**Project: Window Replacement at  
Several Schools**

**Addendum No. 2  
Date: March 26, 2018**

**Owner: Cumberland County Schools  
801 Gillespie Street  
Fayetteville, N.C. 28306**

105 NORTH ELEVATION

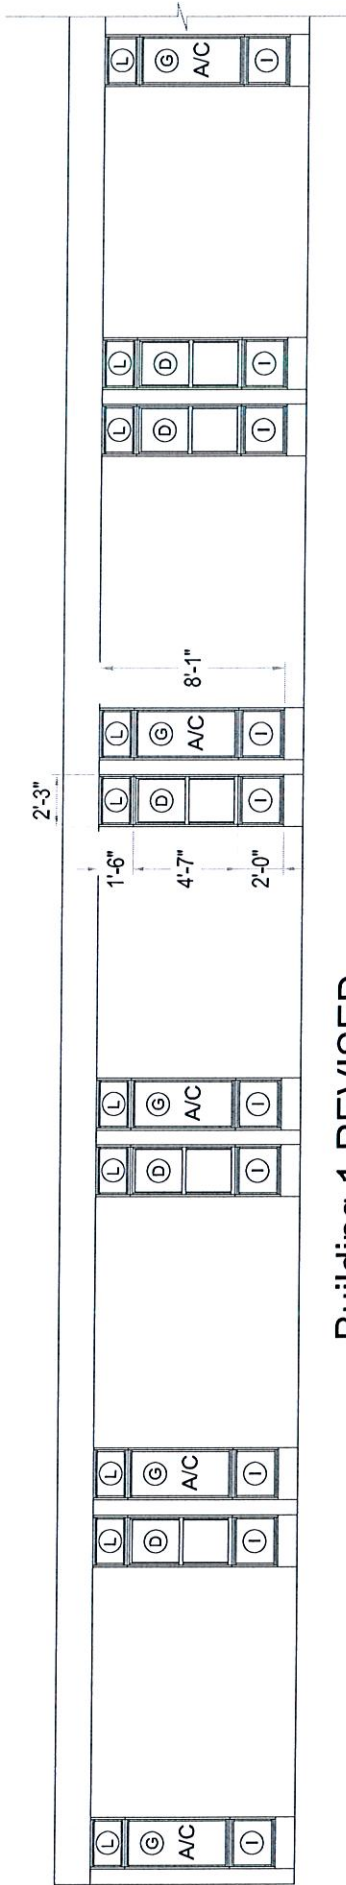
1. There was one window unit omitted from the bid package for Cashwell Elementary School in the Administration Office next to the Conference Room. The Contractor is to include this unit in the Base Bid. A drawing is attached - 105 North Elevation of Building 1.
2. The air conditioning locations for the office area at Cashwell Elementary School were not shown on the elevation. A section of 101 East Elevation, Building 1 was revised to show the air conditioning locations - the drawing is attached.
3. The following is verified as requested for Stedman Elementary School:  
The frame color is white; 1" contour grids; 3 piece mulls are to be used and the glass is to be LowE 366 with argon gas.
